Access Compliance Report

Public Rights-of-Way

Intersection ID: 27236	Main Street: BALLANTYNE CORPORATE PL	Cross Street: BRIXHAM HILL AV	Location: NE
ADA ID: 58FFCDBC8045	Ramp Type: Perp	Initial Pass/Fail: Fail	Overall Compliance: No
Severity Score: 13.75			
Codes/Mitigation Info/Possible Solution		Field Measurements/Component Compliance

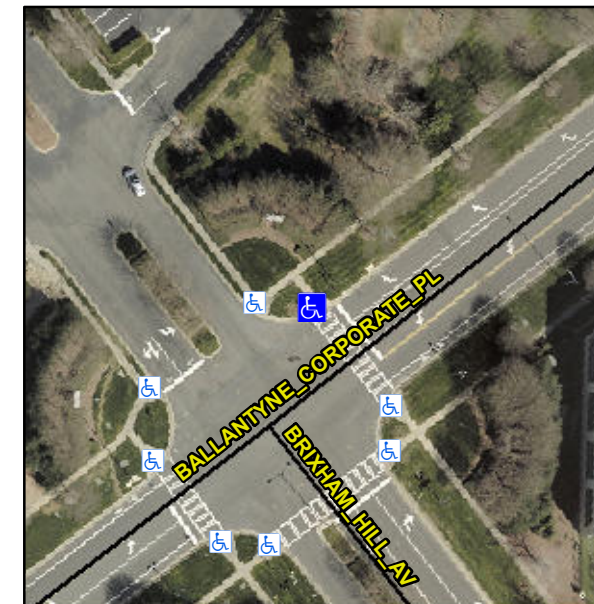
R304.2.2, R304.5.3

Compliance	Description	Data	Compliance	Description	Data
N/A	Ramp Length (in)	119.0	No	Ramp Slope (%)	8.8
Yes	Ramp Width (in)	48.0	No	Ramp XSlope (%)	2.5
N/A	Flare Type LT	N/A	N/A	Flare Type RT	N/A
N/A	Flare Slope LT (%)	N/A	N/A	Flare Slope RT (%)	N/A
N/A	Flare Traversable LT?	N/A	N/A	Flare Traversable RT?	N/A
N/A	Landing Length (in)	N/A	N/A	DWS Provided?	N/A
N/A	Landing Width (in)	N/A	N/A	DWS Contrast?	N/A
N/A	Landing Slope (%)	N/A	N/A	DWS Length (in)	N/A
N/A	Landing X Slope (%)	N/A	N/A	DWS Full Width?	N/A
N/A	Landing Curb? (Y/N)	N/A	N/A	DWS Offset (in)	N/A
N/A	Shared Landing?	N/A			
N/A	Gutter Ponding?	N/A	N/A	Gutter Slope (%)	N/A
N/A	Gutter Lip Ht (in)	N/A	N/A	Gutter X Slope (%)	N/A
N/A	Painted X Walk1?	Yes	N/A	Painted X Walk2?	N/A
	X Walk 1 Direction	To SE		X Walk 2 Direction	N/A
N/A	X Walk 1 Width (in)	112.0	N/A	X Walk 2 Width (in)	N/A
	X Walk 1 Slope (%)	2.5		X Walk 2 Slope (%)	N/A
	X Walk 1 X Slope (%)	2.8		X Walk 2 X Slope (%)	N/A

Remove & Replace Entire Ramp.
